CONSERVATION TEAM CONSULTATION APPLICATION RESPONSE

APPLICATION REF:	25/02497/FPH & 25/03115/LBC
CASE OFFICER:	VW
APPLICATION SITE:	Rye End Farm, Green Lane, Codicote, Hitchin, Hertfordshire SG4 8SU
DESCRIPTION OF WORKS:	Single storey lean-to plant shed on north side of main barn.

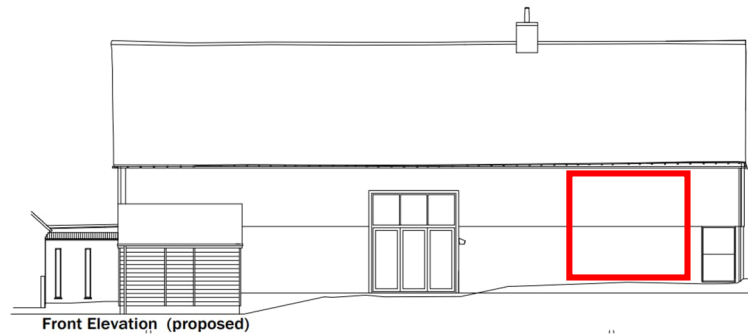
Plant room to be re-sited at the top north-west corner of the Main Barn closer to the kitchen and door to facilitate closer services. MS/VW raised no objection to this in principle, but it would be preferable to leave the existing personnel door exposed on this elevation. Amended drawings to be issued by SL.

My understanding is that the plant-shed would be relocated approximately where I have indicated in red outline below.

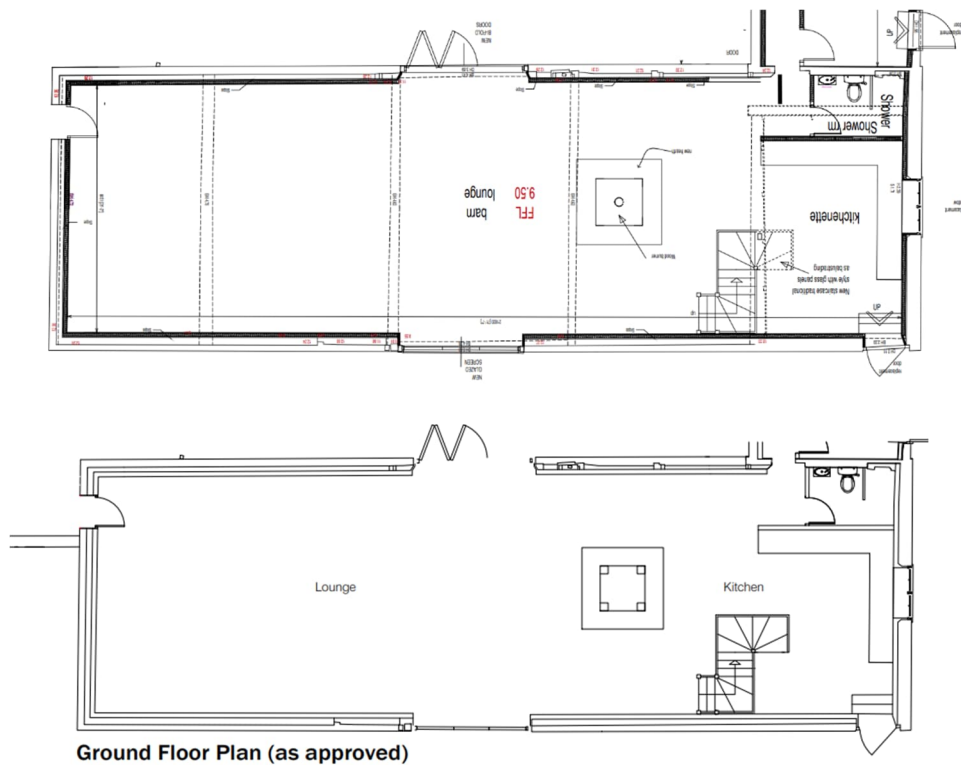
What I did not raise on site but are important issues to consider are the fenestration and chimney stack.

The consented ground floor plan (immediately below) shows the position of a log burner and flue, and the latest ground floor also reflects this arrangement (further below).

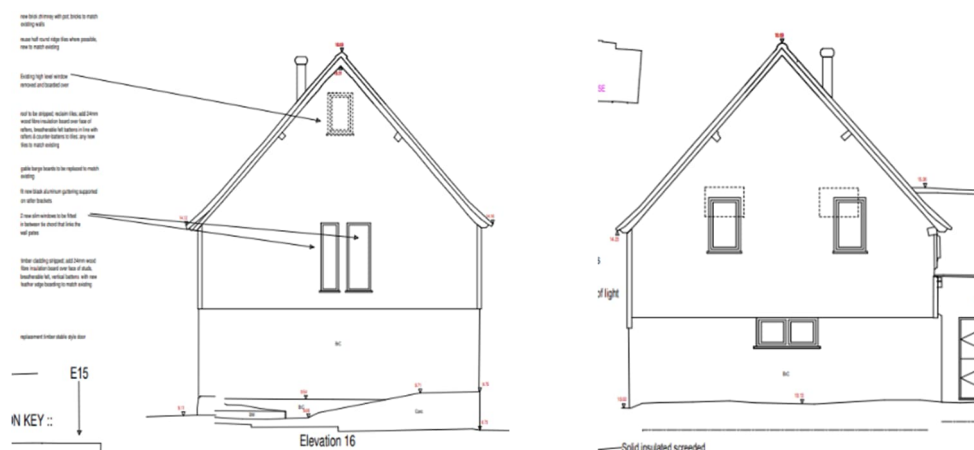
Regarding the fenestration, whilst I am happy to see the lower two windows on consented Elevation 16 (below left) omitted I would have thought that accessibility/maintenance to what would then be a higher window in the apex (opening consented to be boarded over) may be more problematic.

If the applicant wishes to retain a window at this level, then this will require LBC and I advise on a plain glazed opening with no glazing bars to avoid an overly domestic

appearance. I also advise that glazing bars are omitted from the windows in the opposite gable as was the case with consented Elevation 18 (below right).
